## Product Change Notification

**1. ECN #:** 242713

- TFM - .050 X .050 MICRO STRIPS

- TFM-1XX-XX-X-DH-XX

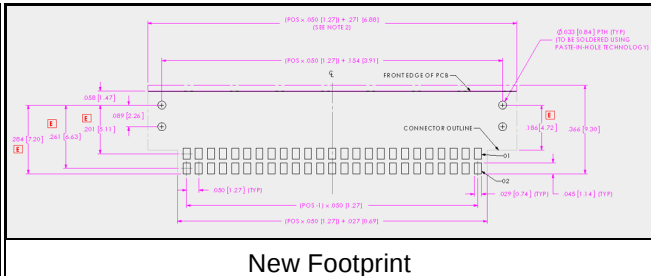
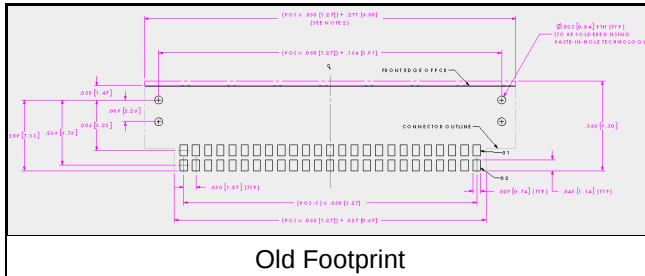
Updating the footprint layout to provide better contact to pad alignment.

The product design remains unchanged. The pad layout/footprint has been updated.

Provides better alignment of part leads to contact pad layout on mating PCB.

- Fit - Pad locations in reference to signal pin locations have been updated to better match the product.
